**ADDENDUM NO. 2 TO PROJECT NO. 44811**

**REPLACE THE HVAC SYSTEMS, BUILDINGS 29 AND 66  
INDUSTRY LIMITED SECURE CENTER  
375 RUSH-SCOTTSVILLE ROAD  
RUSH, NY**

March 6, 2015

DRAWING NUMBER: **M-012**

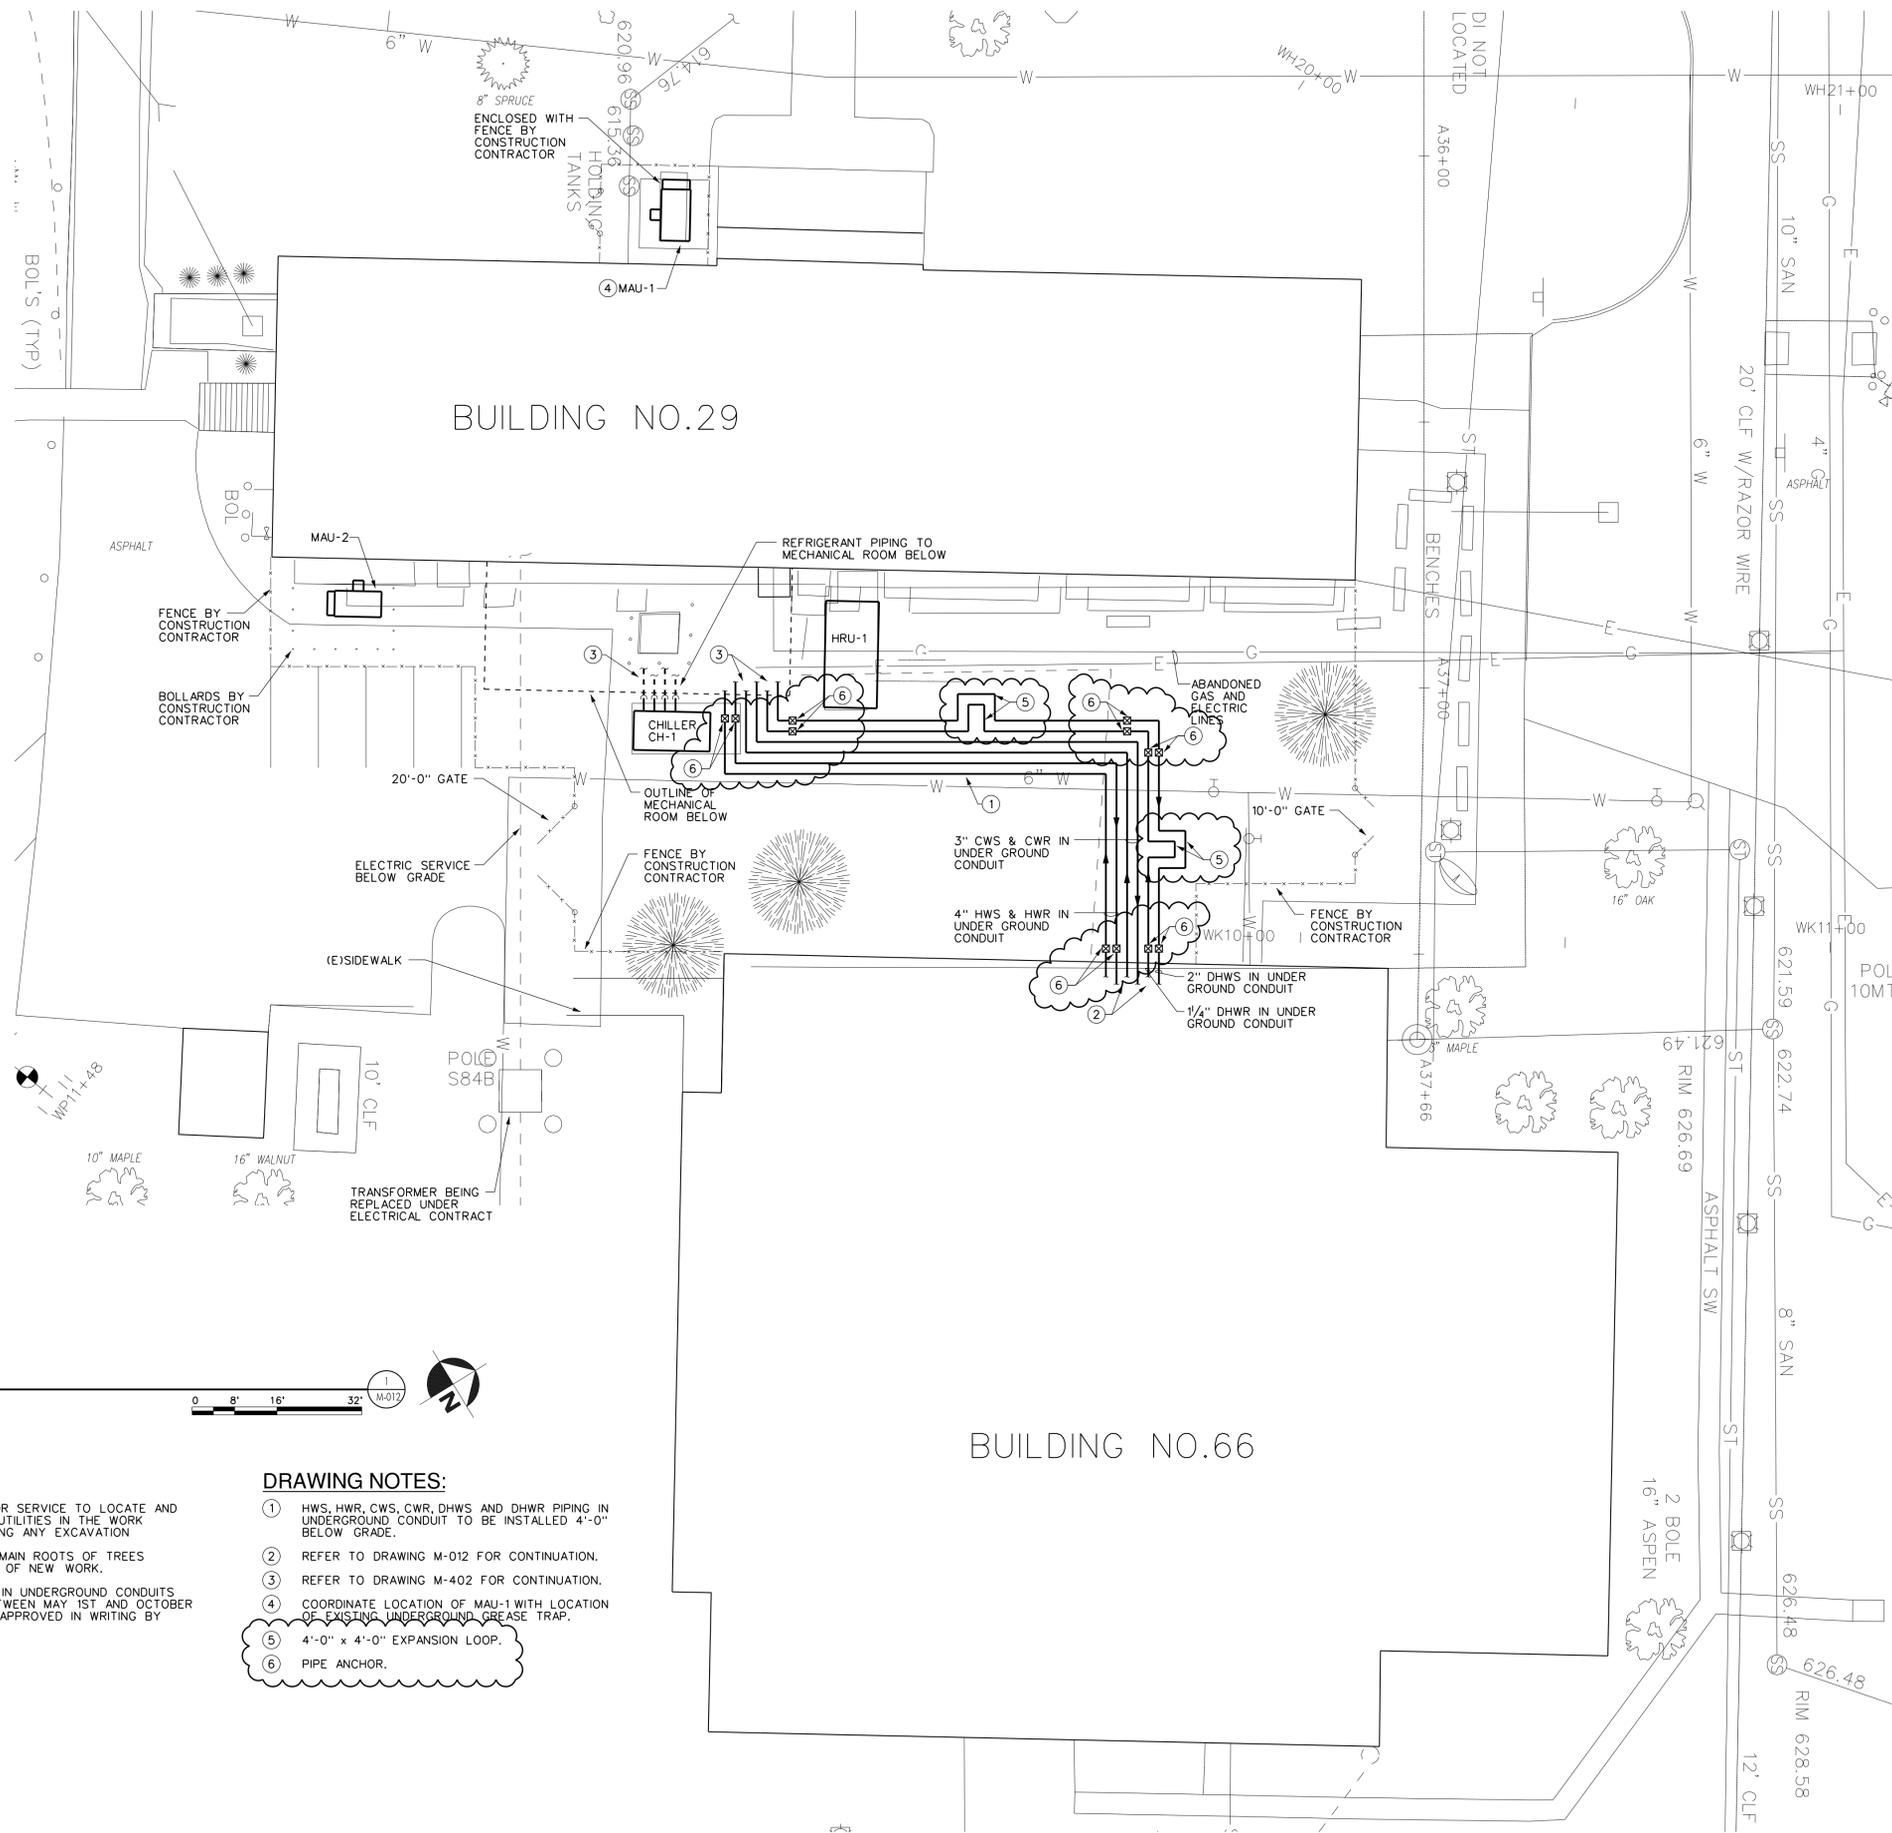
1. Refer to Drawing M-012 - Site Plan:
  - A. Replace with new Drawing M-012 - Site Plan included with this Addendum.
